*Preliminary Consultation*  
**MONTGOMERY COUNTY HISTORIC PRESERVATION COMMISSION**  
**STAFF REPORT**

<b>Address:</b>	4722 Cumberland Ave., Chevy Chase	<b>Meeting Date:</b>	8/14/2024
<b>Resource:</b>	Post-1916 Resource <b>Somerset Historic District</b>	<b>Report Date:</b>	8/7/2024
<b>Applicant:</b>	Agnes Holland & Matthew Grohowski Tahani Share, Architect	<b>Public Notice:</b>	7/31/2024
<b>Review:</b>	Preliminary Consultation	<b>Staff:</b>	Dan Bruechert
<b>Proposal:</b>	Building Addition, Porch Construction, and Rear Deck Construction

*Figure 4: Existing (top) and proposed (below) east elevations.*

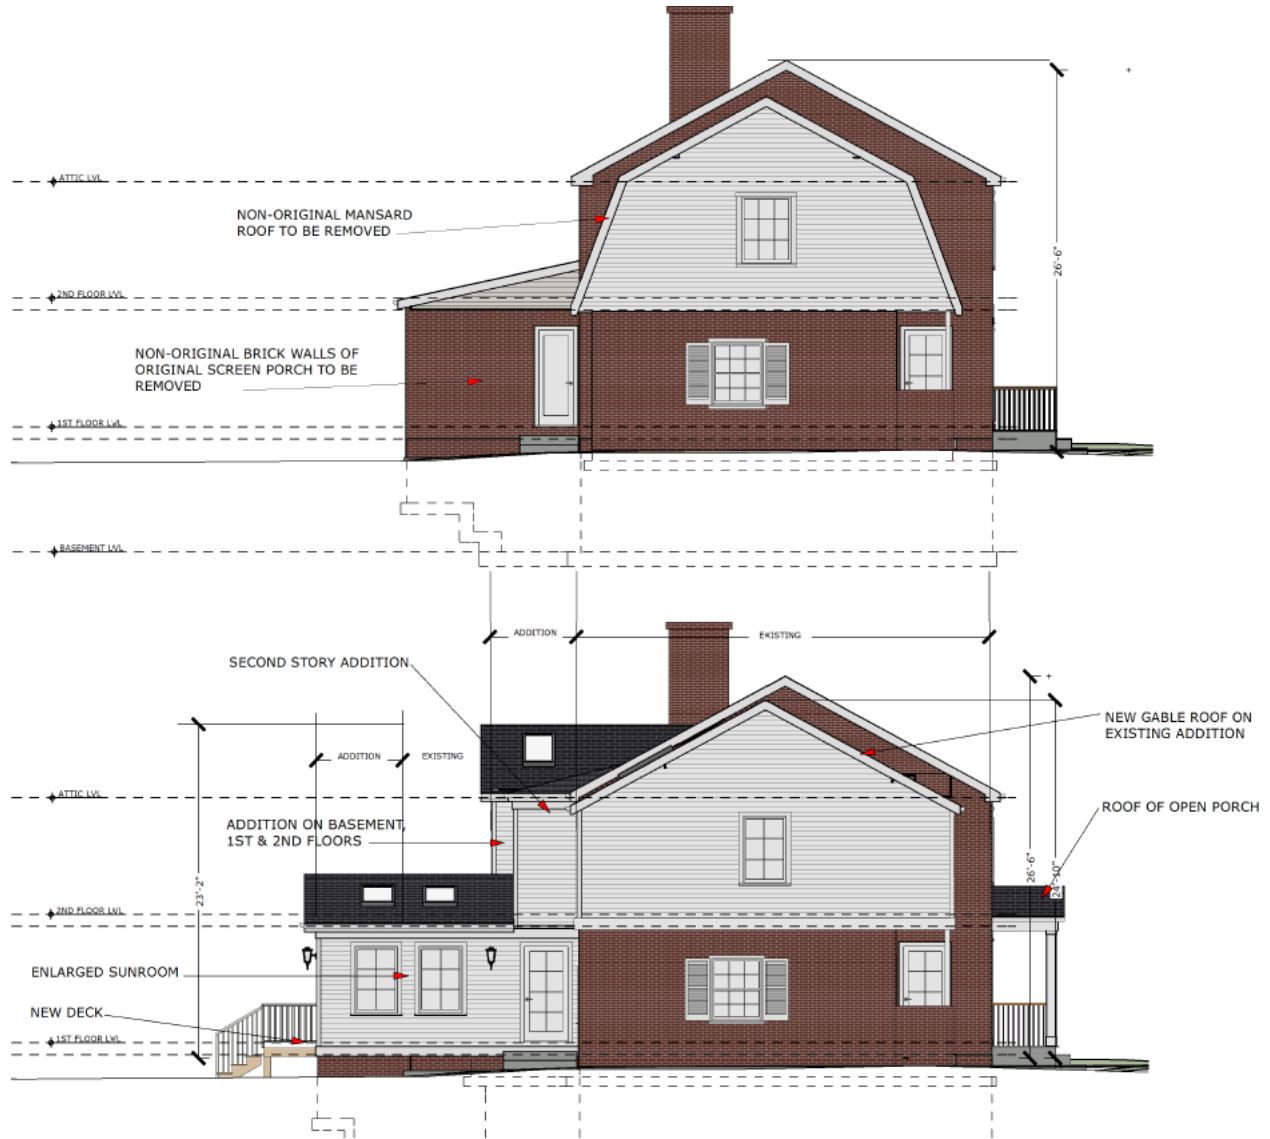
Originally, the roof over the garage was a low-sloped side gable. Sometime later, the current gambrel-roofed addition was added. The applicant proposes to remove the existing roof and construct a side gable addition (see Figure 3, above). The 2<sup>nd</sup> floor will be sided in fiber cement clapboards and will have a multi-light aluminum-clad wood window with shutters. The left (east) elevation will have a single six-light casement window. On the rear elevation, the addition will have a single six-light casement window and the applicant proposes to install two skylights.

Because detailed specifications for the windows were not included in the application materials, Staff recommends the windows have permanently affixed interior and exterior grilles with a spacer bar between the glass. Additionally, no information about the proposed shutters was included in the application materials. Staff recommends the shutters installed in the 2<sup>nd</sup>-story addition match the existing front

elevation shutters in size, materials, and installation. Specifications of the existing shutters need to be submitted with the HAWP application to ensure the new shutters match.

Staff requests feedback from the HPC on the appropriateness of the proposed 2<sup>nd</sup>-story addition modification and the materials proposed.
